Project: Kipnuk Bulk Fuel and Power System
Upgrades

Solicitation No.: 17068

Addendum No. Two

1 ELECTRICAL SERVICE DROP AND LIGHT POLE DETAIL
S1.2 3/4" = 1'-0"

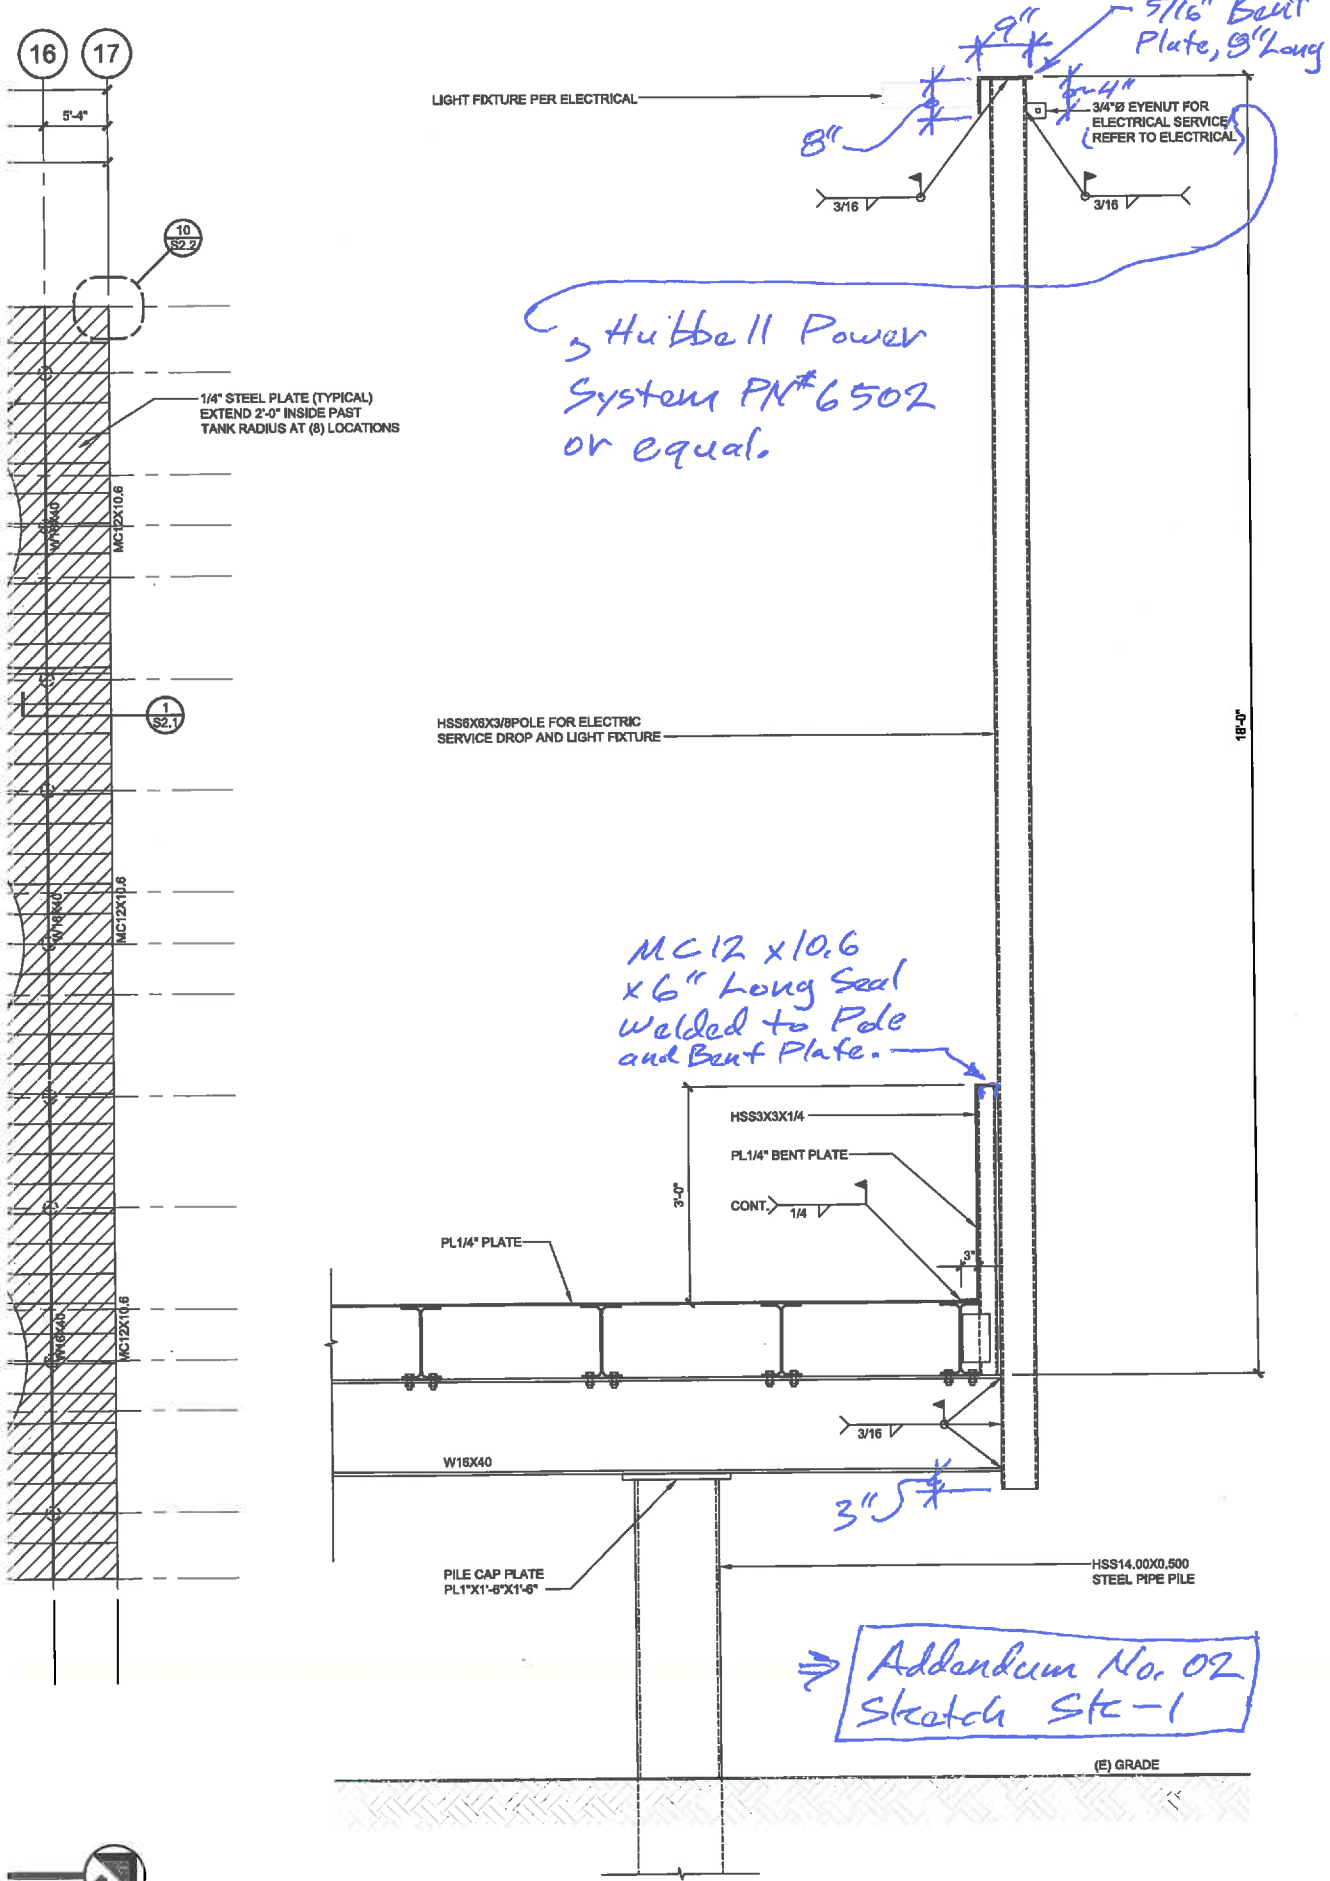
1. ALL WORKS SHOWN ON THE STRUCTURAL DRAWINGS IS INCLUDED IN THE BASE BID.
 2. SEE SPECIFICATIONS SECTION 01 11 13 SUMMARY OF WORK FOR FURTHER CLARIFICATION ON BID ALTERNATES.
- 2) Sheet S1.2 Detail 1, revise detail per attached Sketch SK-1 (attachment B).
 - 3) Sheet S2.2 Details 8 and 9, add the following “Note: All welds inside of the containment dikes and on top of dike walls are continuous seal welds and to be liquid tight. No ‘stitch’ or ‘skip’ welds are allowed except where indicated.”
